Flight Procedures Cover Page	Task Action: FLIGHT CHECK	Task Type: IAP	Estimated Chart Date: 06/12/2025	APWS Task ID: EB8D70DA77FE4640B039A6E6830DF0BF	APWS Project ID: 3A86C31F54404734BC3E786F6C9AFCA1
Procedure: ILS OR LOC RWY 4R AMDT 31		Enroute: NO	Specialist: Blanco, Joseph		Agreement Number:
Airport ID: KJFK			Airport City: NEW YORK		State: NY
Facility ID:	Facility Type:	Flight Inspection Remark Type: New FC Slot			
<div>Procedure Comments: ACTIVE AIRPORT DATA USED REASON FOR PROJECT: AMEND MISSED APPROACH TO TURN SE. FAA FORM 8260-1: NONSTANDARD IFP TO APPLY LPV MISSED CRITERIA TO AN ILS CAT II/III. CONTACT CASIMIR TABAKA 405-954-7931</div> <div><div>QUALITY 38 CHECKED</div><div>QUALITY 34 CHECKED</div></div>

ILS OR LOC RWY 4R (CAT I, CAT II and CAT III)
John F. Kennedy INTL (KJFK)
New York, New York

2. WAIVER REQUIRED AND APPLICABLE STANDARD:

ILS or LOC RWY 4R
JOHN F KENNEDY INTL (JFK)

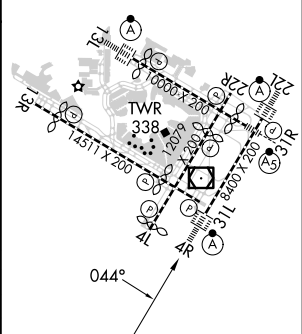
MISSED APPROACH: Climb to 420 then climbing right turn to 2000 on heading 145° and JFK VOR/DME R-118 to SNIPY and hold.

ALTERNATE MISSED APPROACH FIX

ILS RWY 4R (CAT II & III)
JOHN F KENNEDY INTL (JFK)

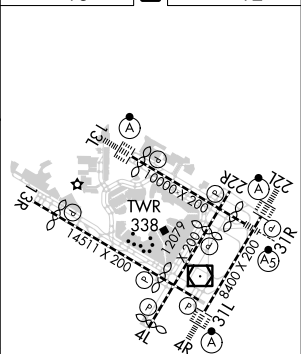
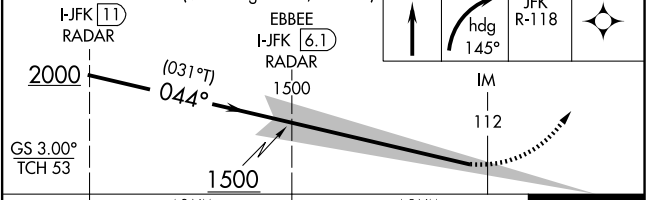
MISSED APPROACH: Climb to 420 then climbing right turn to 2000 on heading 145° and JFK VOR/DME R-118 to SNIPY and hold.

ALTERNATE MISSED
APPROACH FIX

OLD

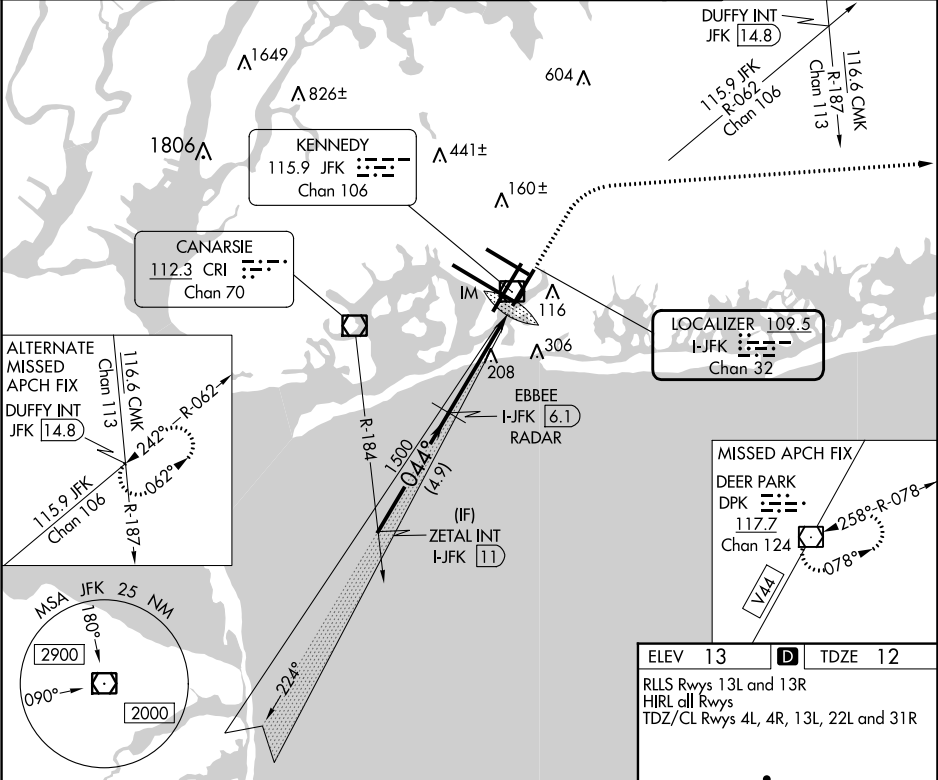
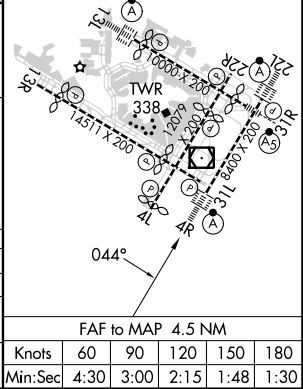
RADAR required for procedure entry.		ALSF-2	MISSED APPROACH: Climb to 800 then climbing right turn to 4000 heading 099° and V44 to DPK VOR/DME and hold.
Simultaneous approach authorized.

MISSED APPROACH: Climb to 800 then climbing right turn to 4000 heading 099° and V44 to DPK VOR/DME and hold.
